ROOF REPLACEMENT CAPITAL PLAZA

FRANKFORT, KENTUCKY

REVISION NO. 1 11 APR. 2005

"AS-BUILT" NOTE:

DETAIL B A-7 1/2 F.S.

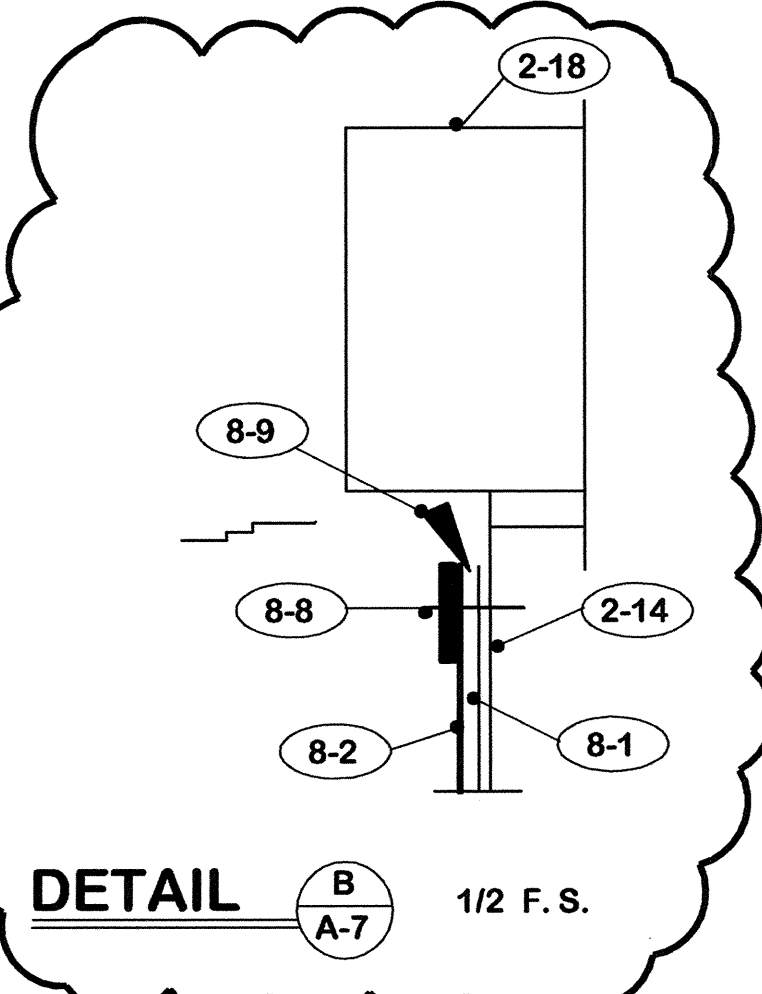
"AS-BUILT" NOTE:
 1. Corrected Detail B/A-7.

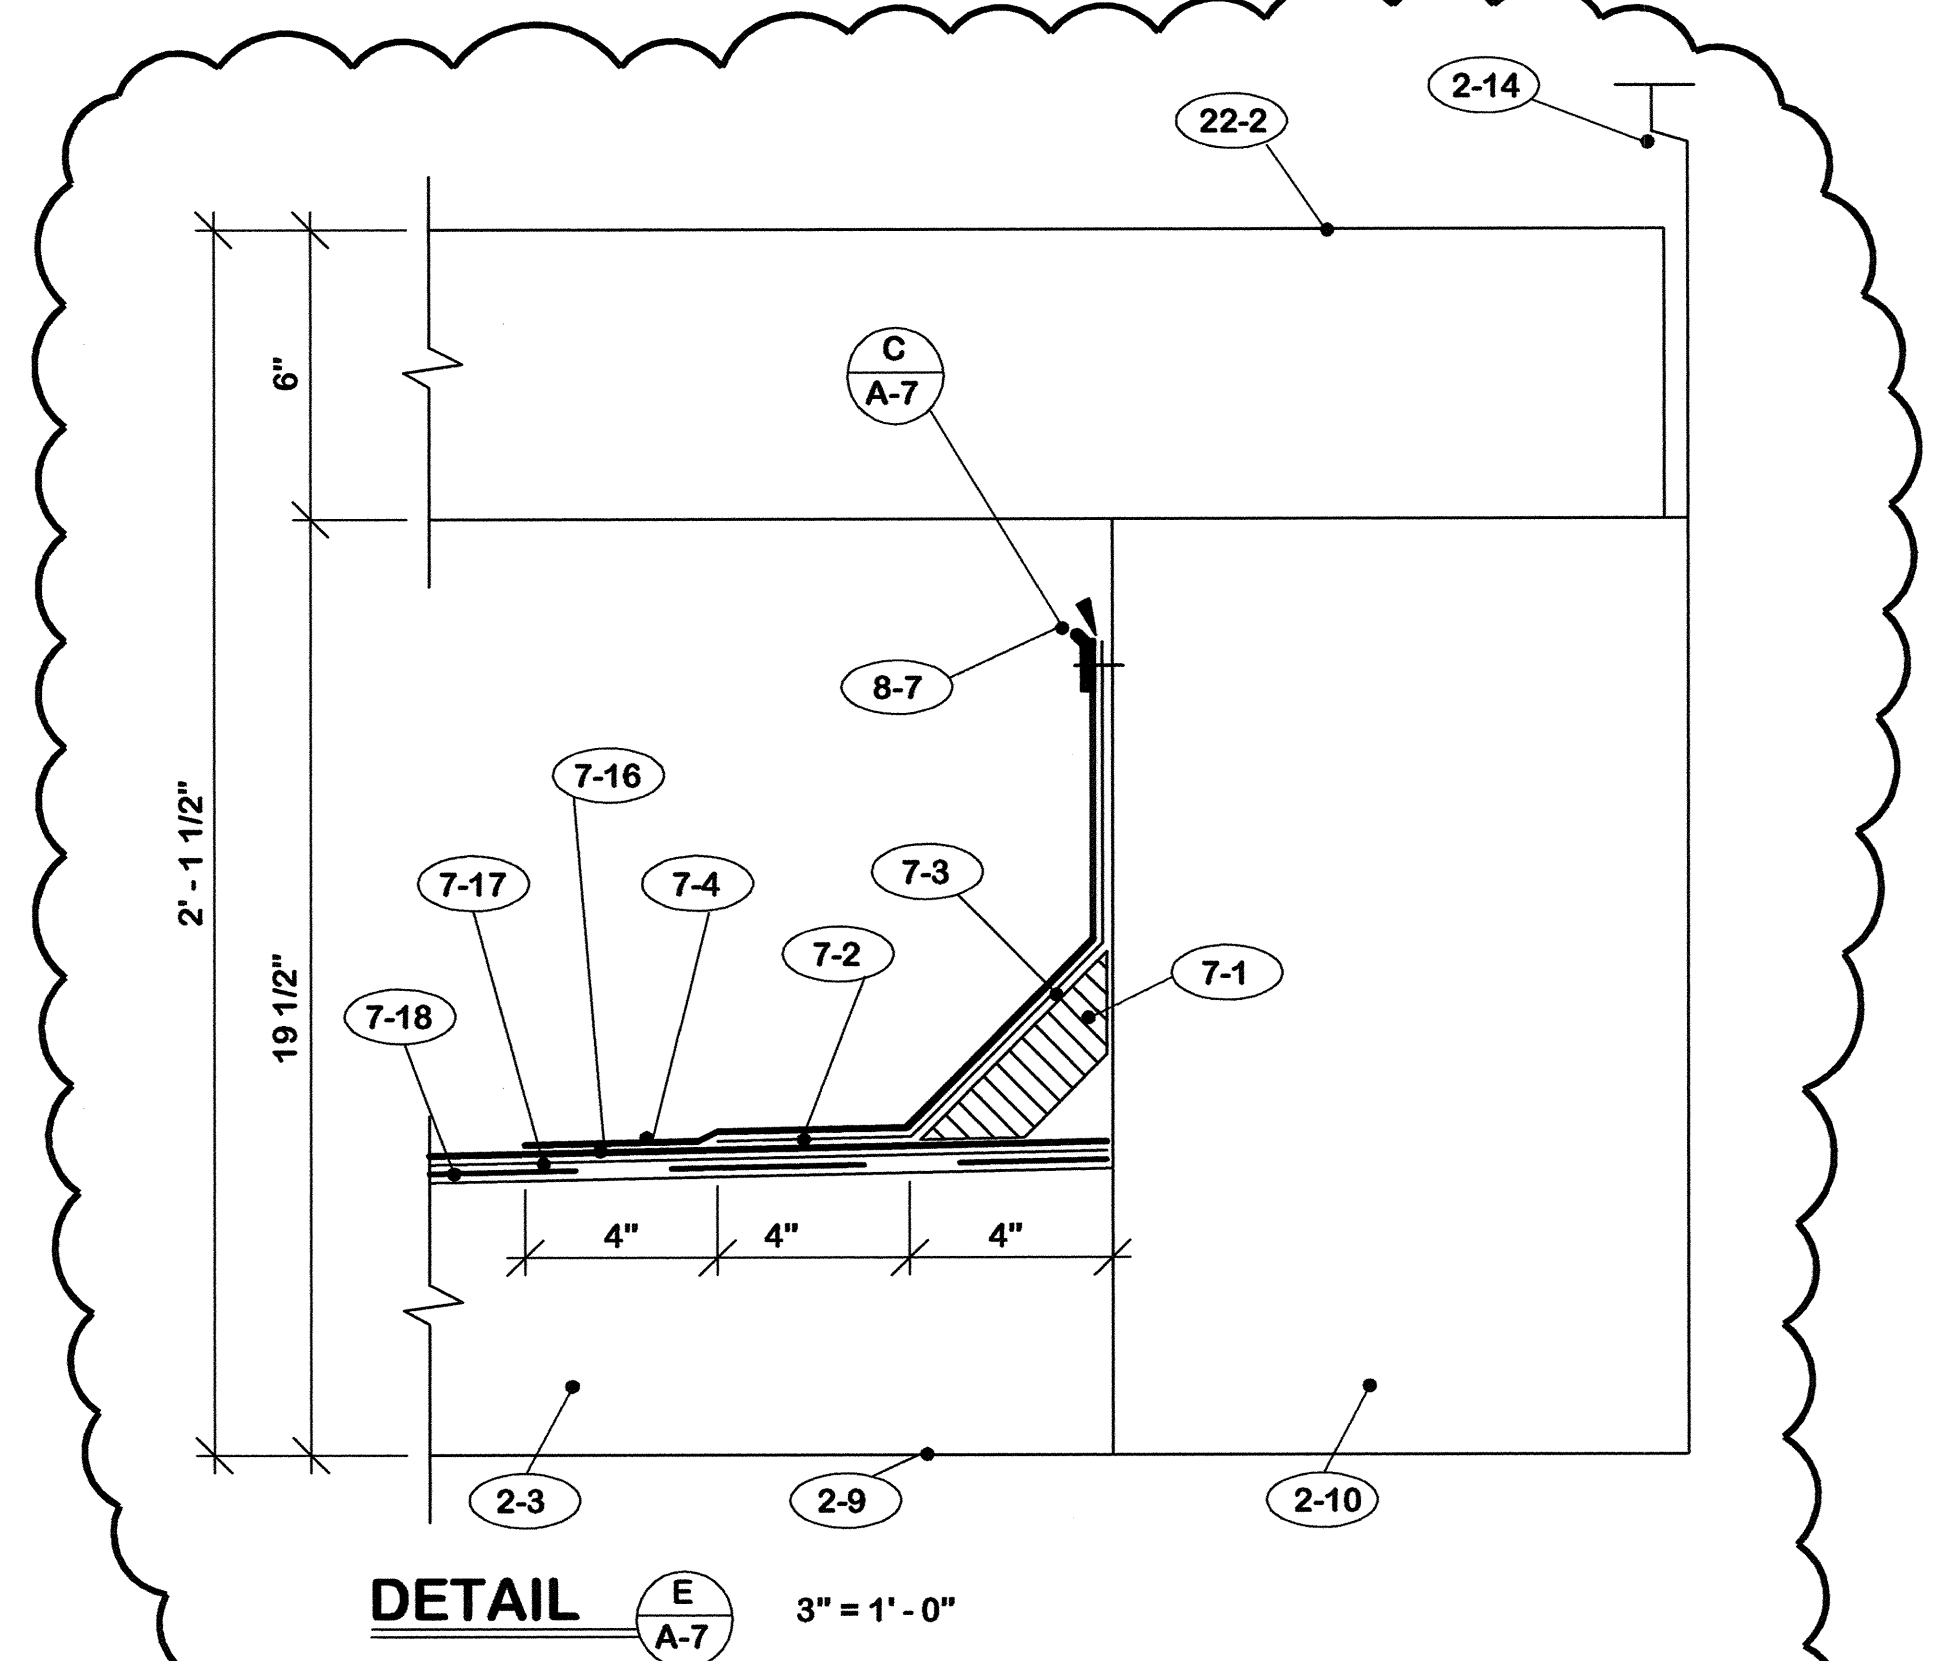
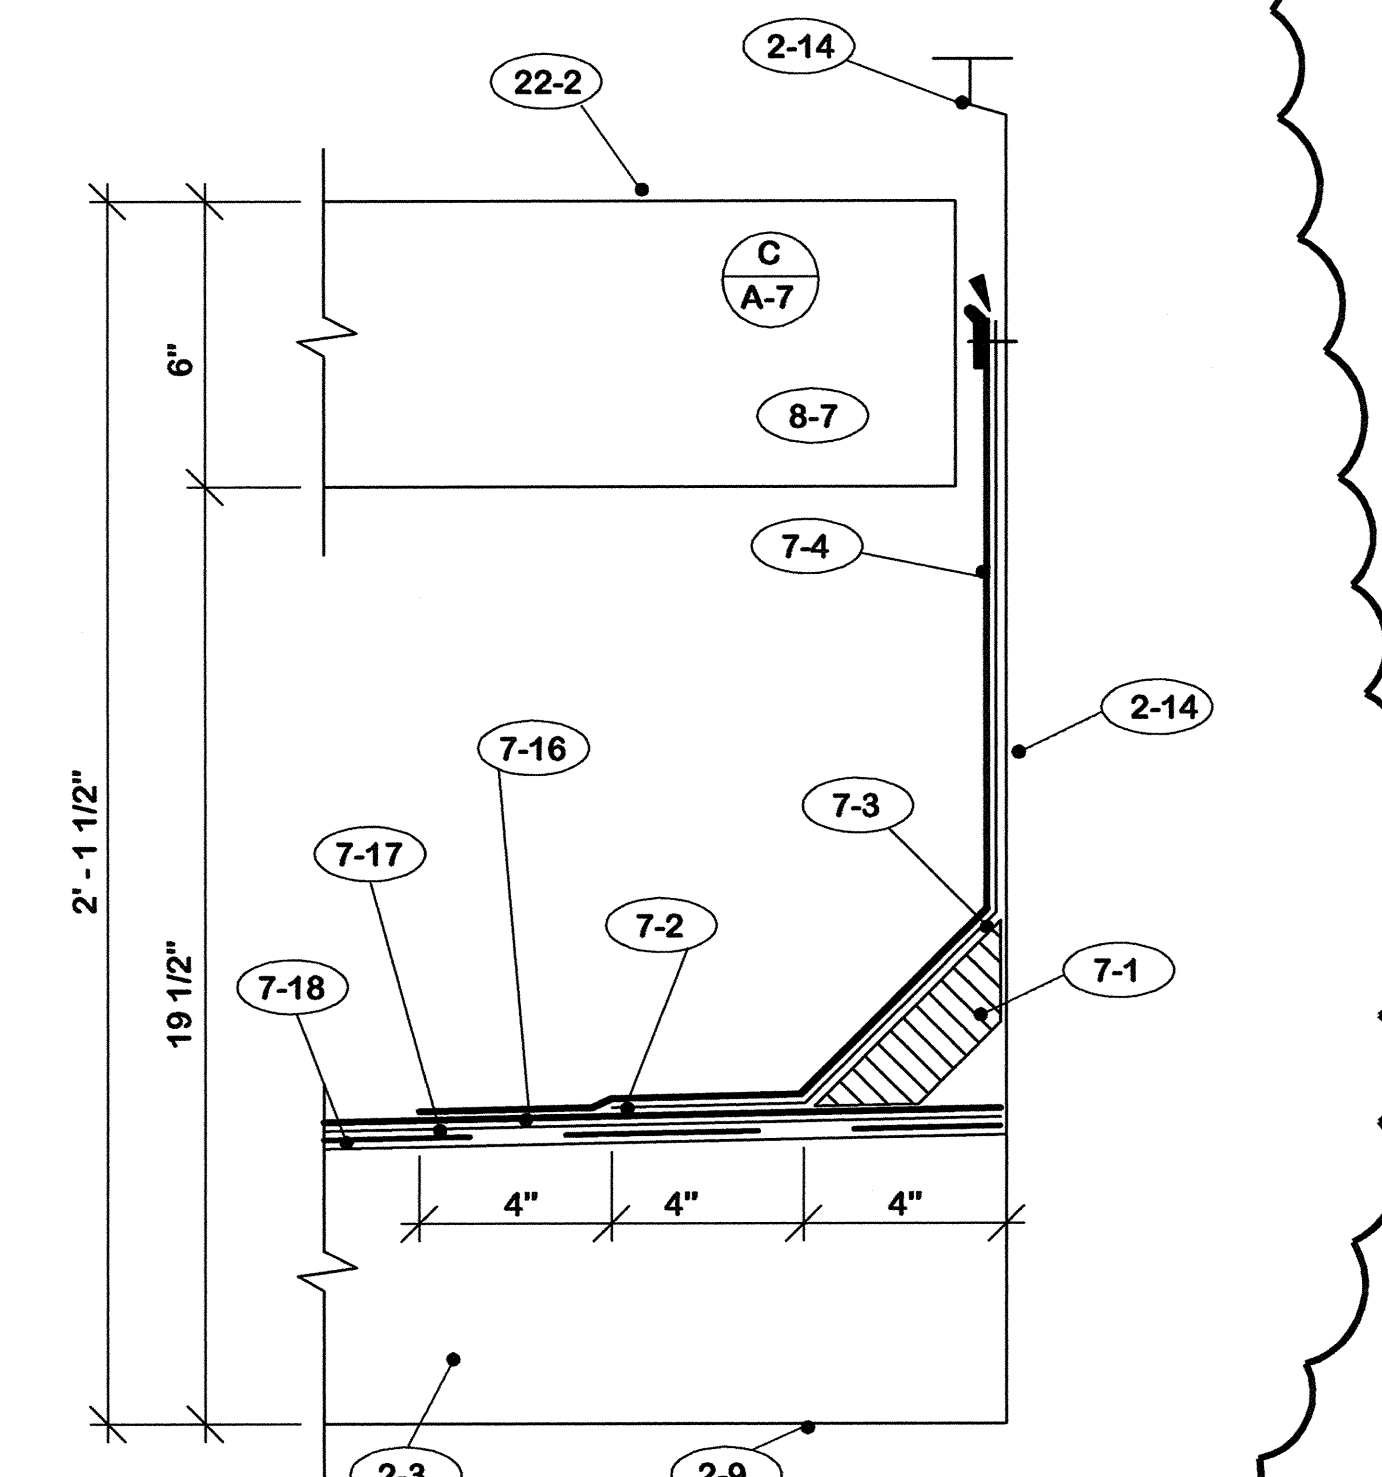
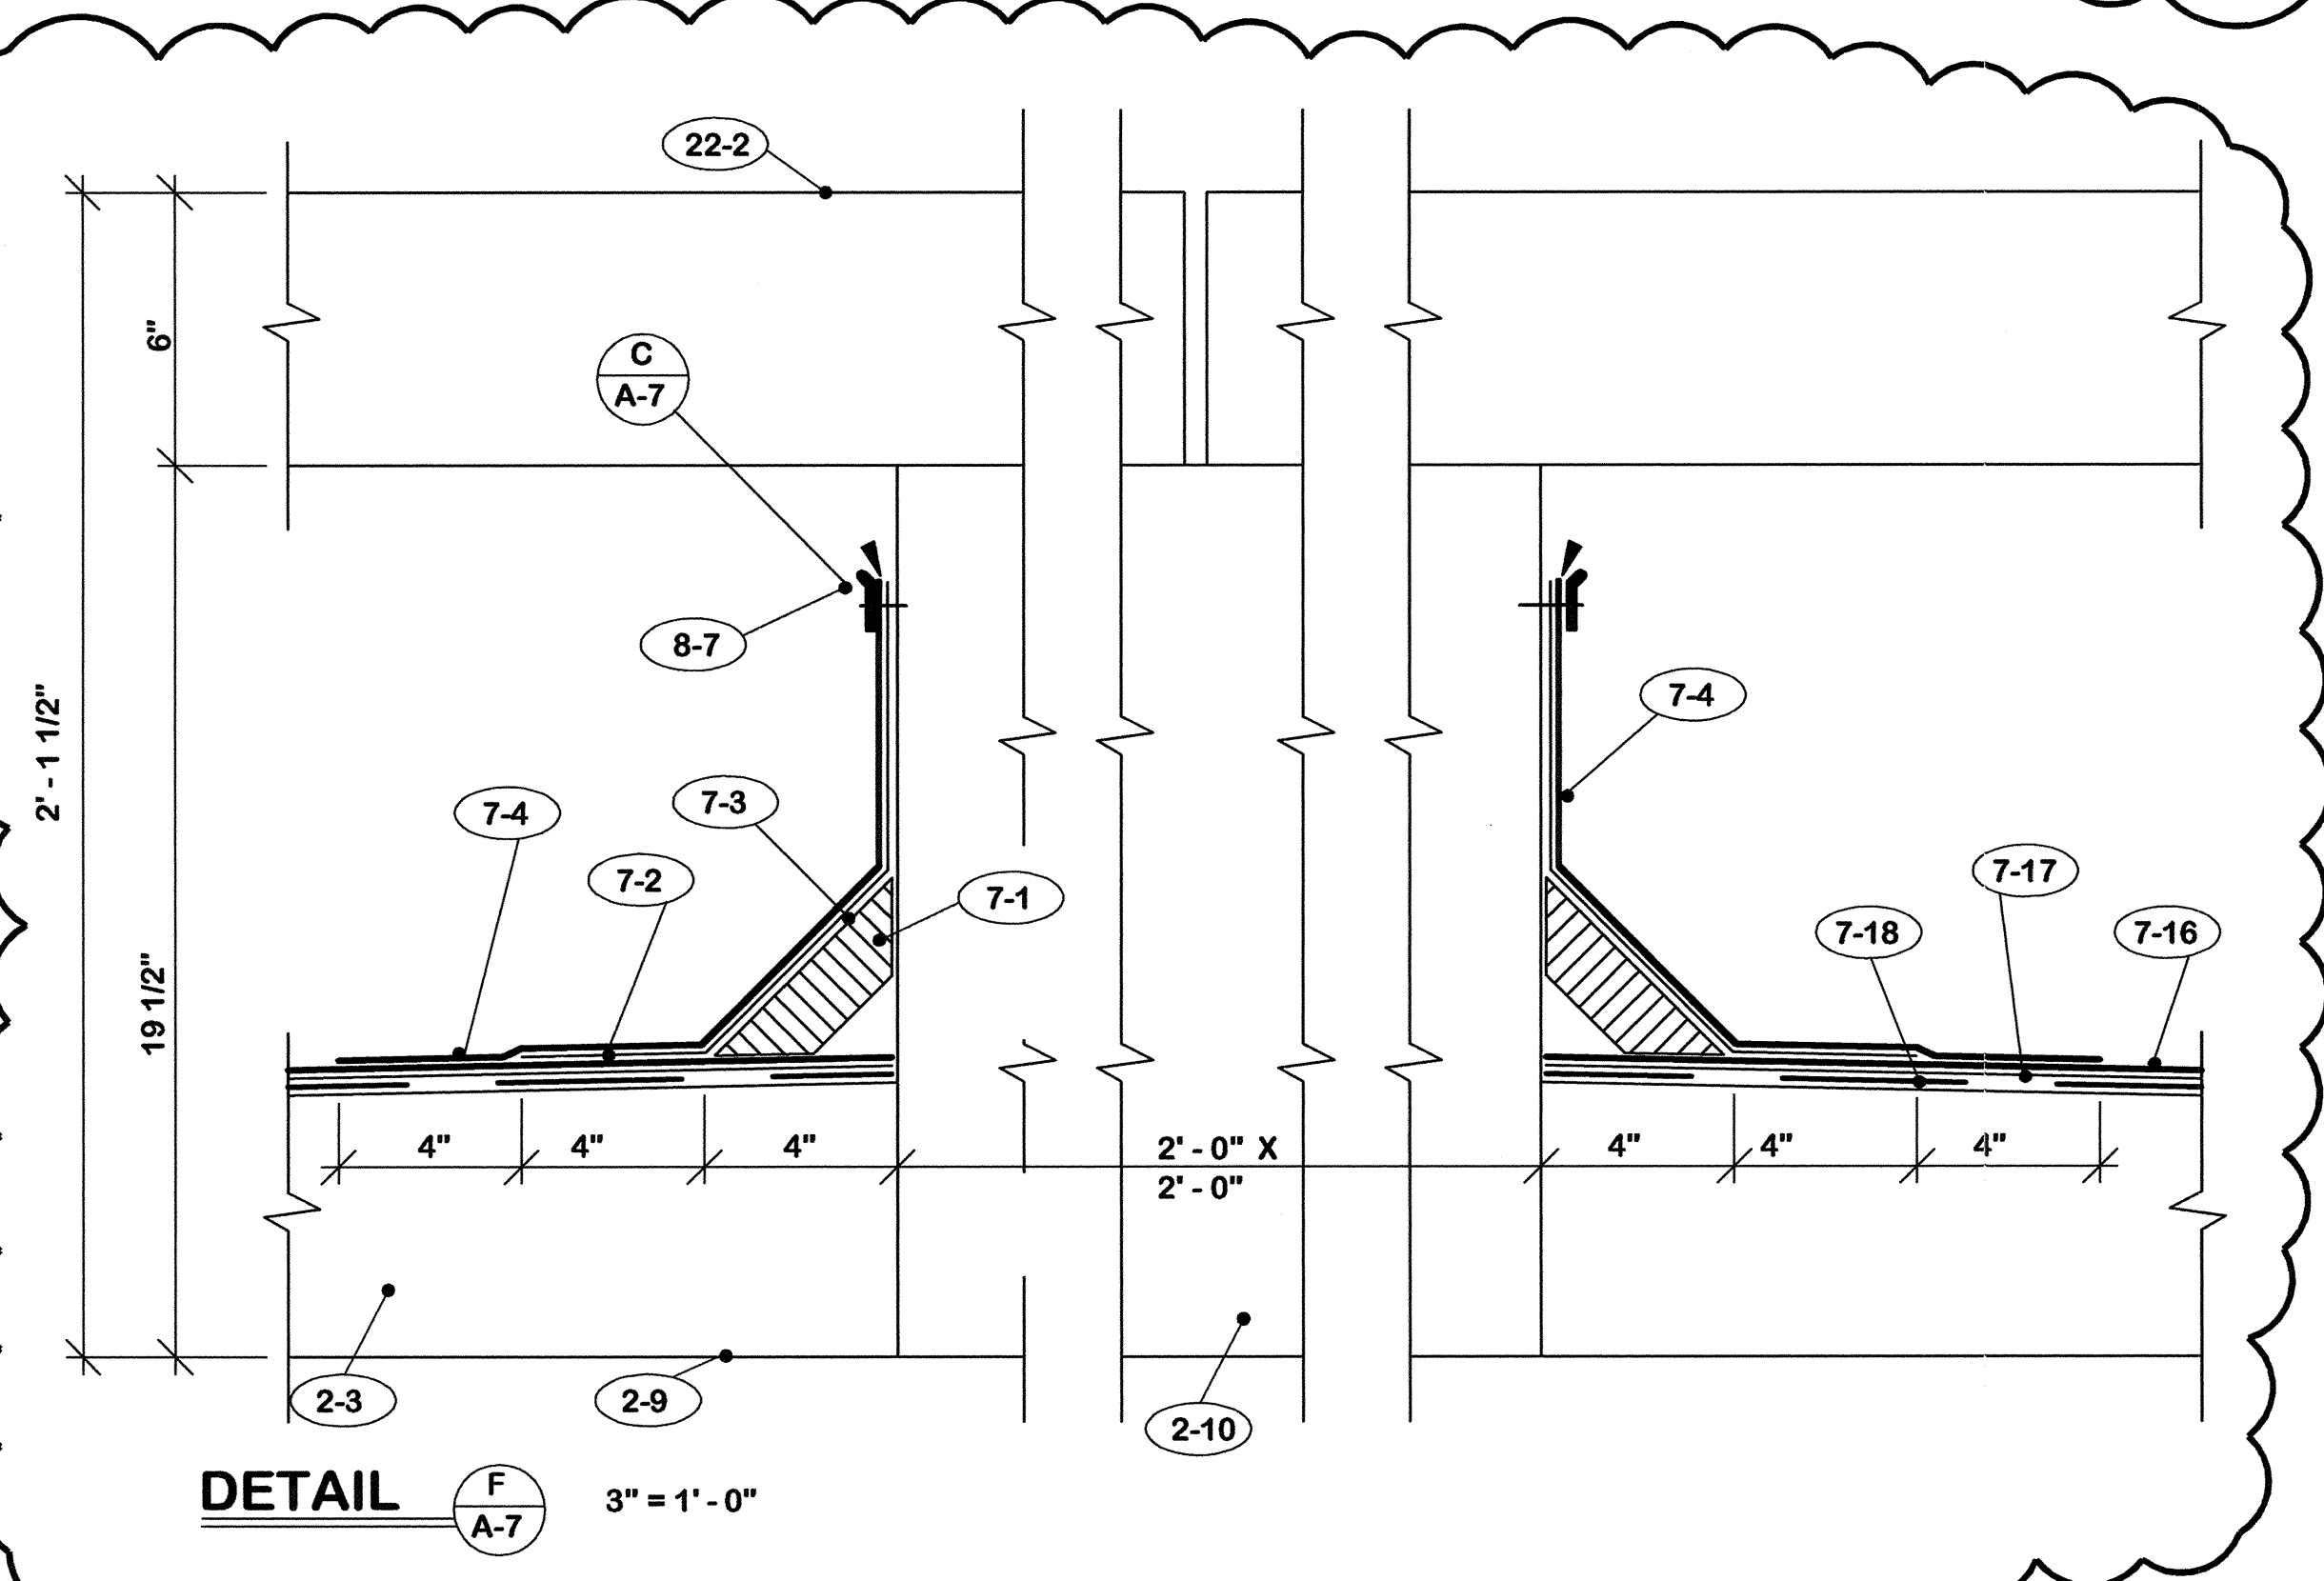
NOTE "A"
 1. Revised Detail F/A-7.
 2. Deleted Detail D/A-7.
 3. Revised Detail E/A-7.
 4. Add Detail H/A-7.
 5. Delete notes 7-8 and 71-8.
 6. Add notes 7-16, 7-17, 7-18, 7-19 & 7-20.
 7. Moved note series 8.
